# Issues with OMA specification versus “traditional “ average power /extinction specification

**Presentation for March 12 - 16 2001 IEEE  
802.3 Meeting**

**Juergen Rahn**

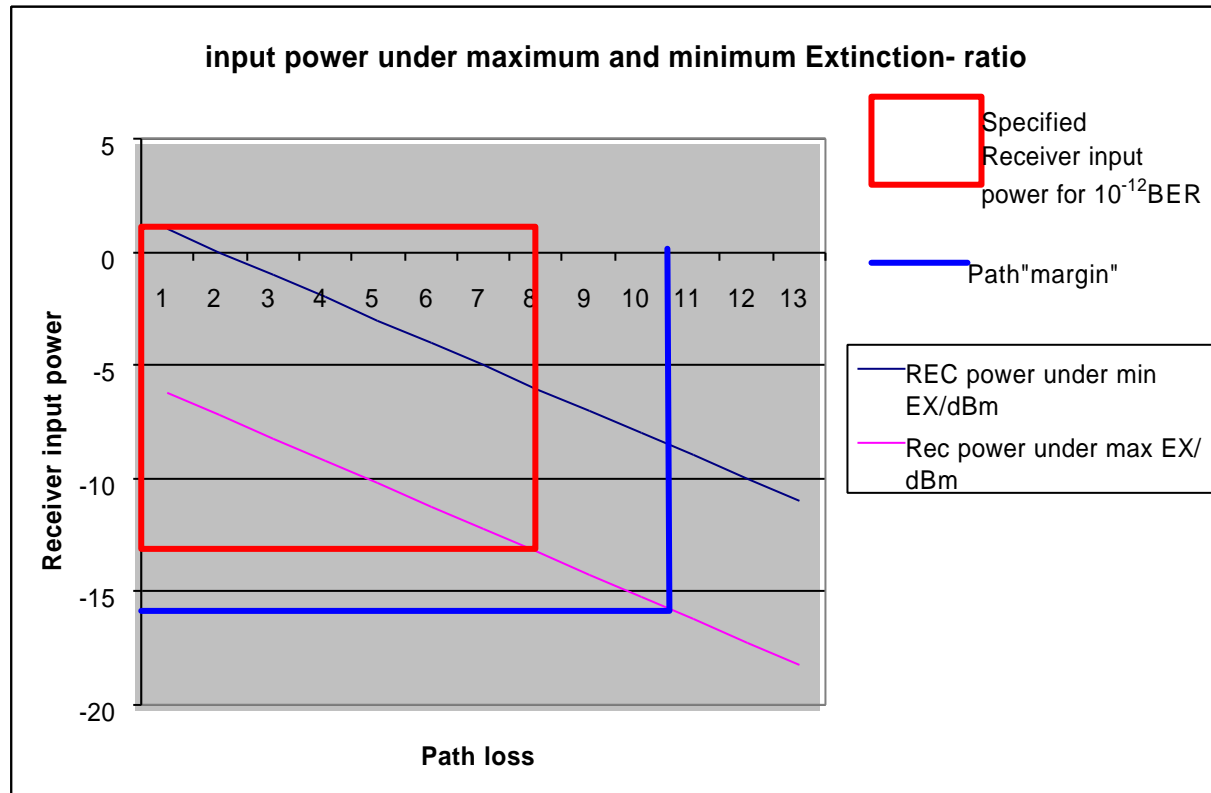
- **Receiver side signal evaluation**

- Normally receiver side test are done using receiver power measurements for evaluating if signal is in range
- This receiver power measurement corresponds to Average power definition of transmitter side specification
  - The Average power definition is most appropriate as the power control algorithm of transmitters is based normally based on average power
- A receiver side OMA spec requires to measure the receive signal as OMA to check whether the path attenuation is in allowed range.
  - OMA measurement means a precise receive side Eye measurement
